July 22, 2019

**RE: Red Dog Mine Reclamation and Closure Plan Amendment Request for an amended the Cover Design on the Main Waste Dump**

Figure 1 Current 2016 Approved MWD Cover Design

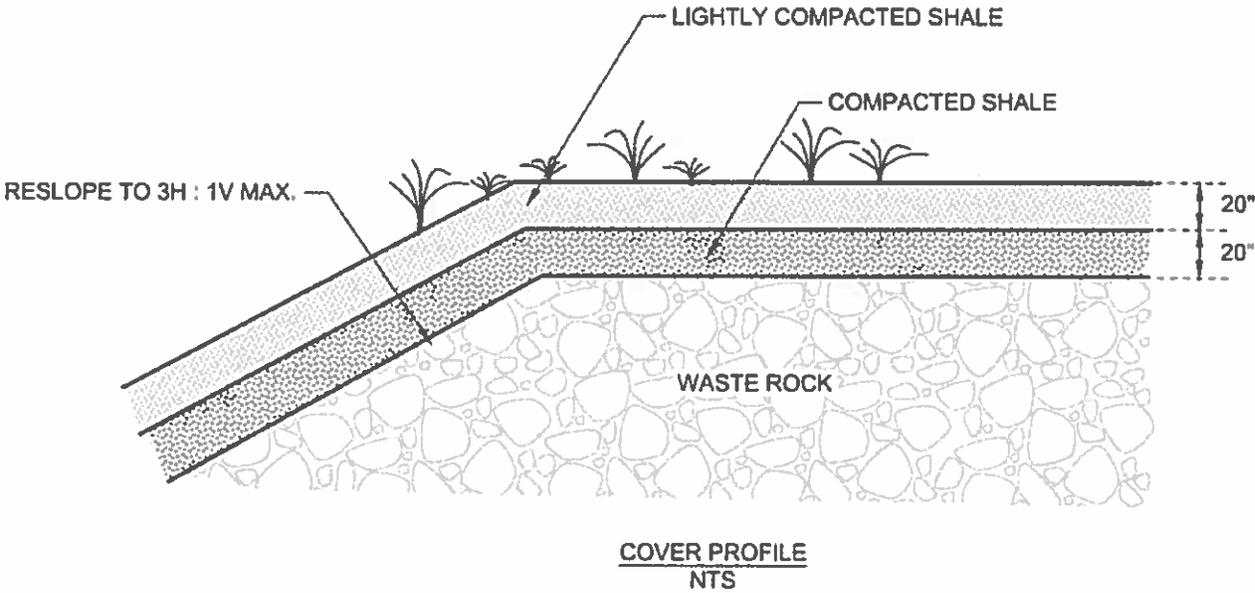
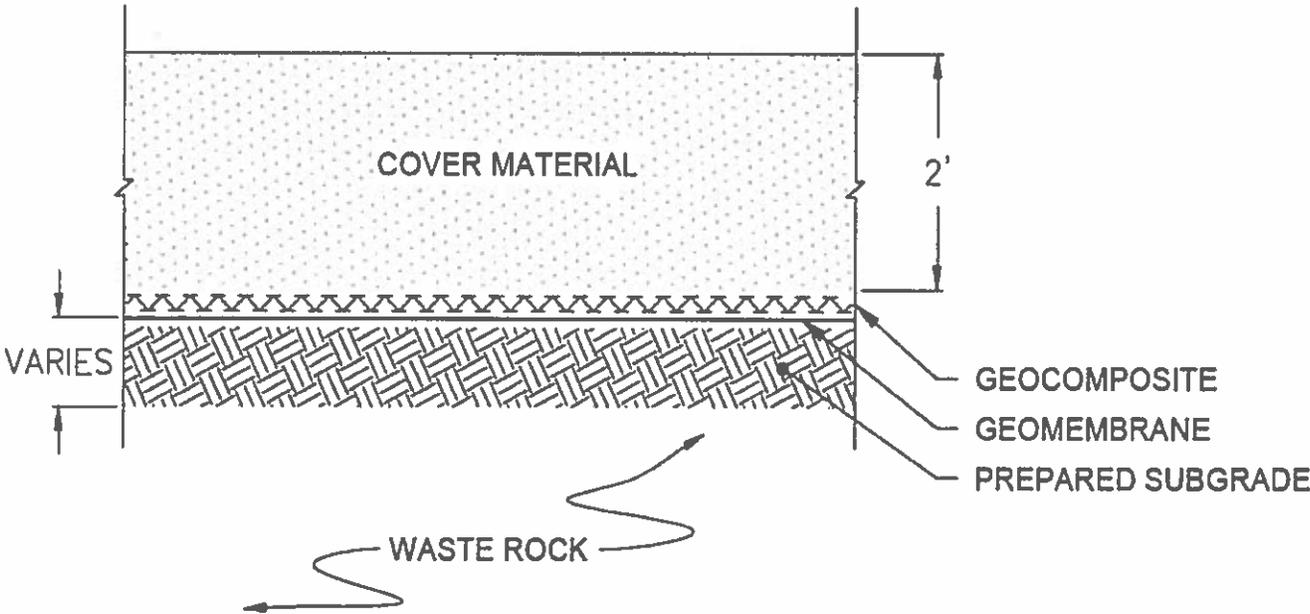
The current cover design for the MWD incorporates two 20" layers of cover material (shale); a compacted lower zone and an upper uncompacted zone to support vegetation. Figure 1 depicts cross sectional layout for this design. Figure 2 depicts a cross section of the proposed design; essentially the lower compacted soil layer is replaced with geosynthetic materials.

With the geosynthetic material replacing the lower 20" compacted layer in the current design, 24" cover material will be placed on the geosynthetic materials, this will be accomplished in two uncompacted 12" lifts. No "hold time" is necessary to allow the material to weather to achieve sufficient compaction. Once the final lift of cover material has been placed the area will be seeded.

Figure 2 –Proposed MWD Cover Design
